# Product Change Notification

**PCN-A-1040407**

**PCN Topic:** Change the R17ID7T-CHM1 & R17IB7T-CHM1 panel and outline dimension.

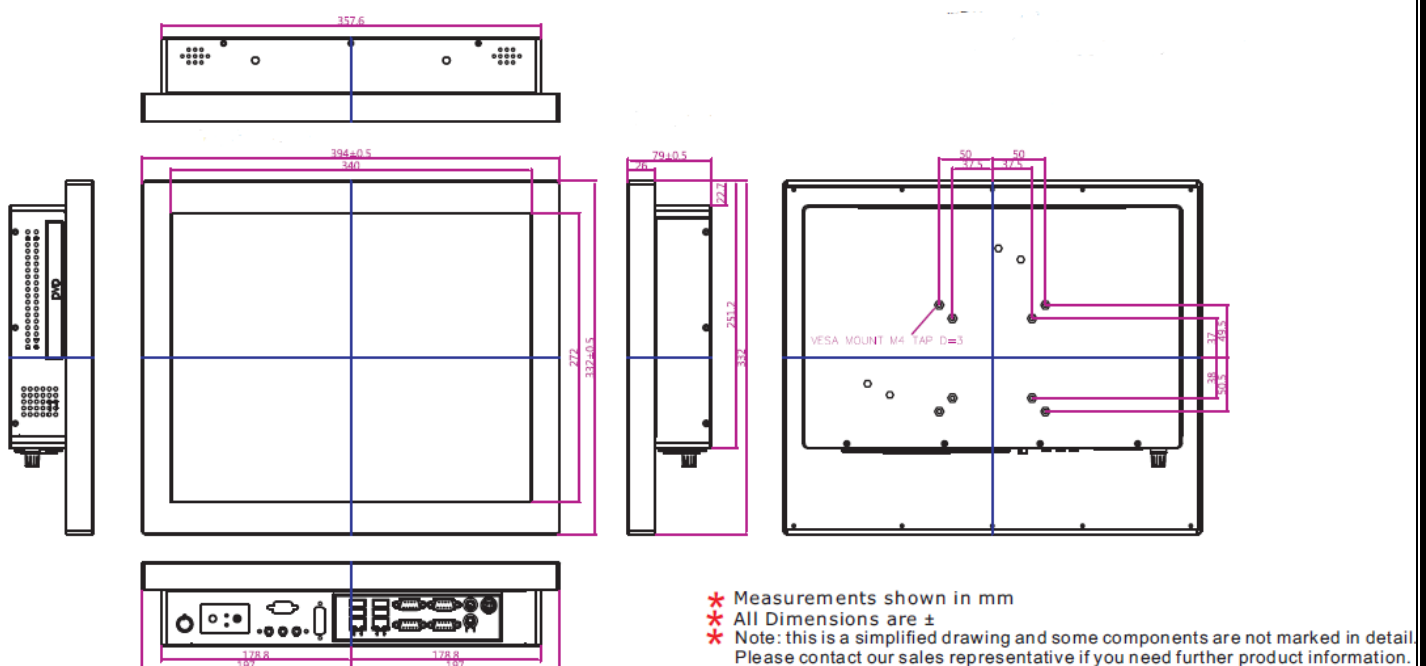
Provide good product and always improve product line is Winmate's core ability. Therefore we will change our R17ID7T-CHM1 & R17IB7T-CHM1 product to new LED panel.

**New outline drawing:**

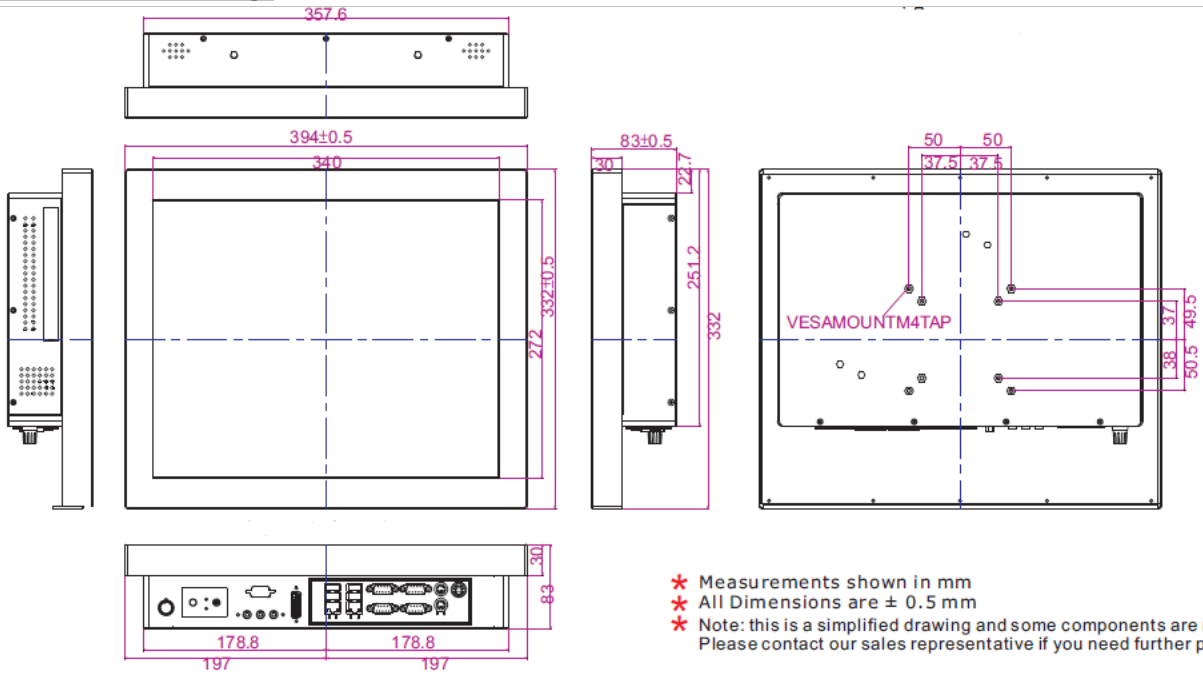
The new panel is thicker so that provide thicker outline dimension than before. This panel change will not affect brightness. The compare table as below.

Previous 17" M1	New 17" M1
<b>Model name</b>	17" M1 Series	17" M1 Series
<b>Backlight unit</b>	CCFL	LED
<b>Brightness(nit)</b>	350	350
<b>Contrast ratio</b>	1000	1000
<b>View angle</b>	-85~85(H); -80~80(V)	-85~85(H); -80~80(V)
<b>Resolution</b>	1280x1024	1280x1024
<b>Color depth</b>	16.7M	16.7M
<b>Outline dimension</b>	394x332x79 mm	394x332x83 mm
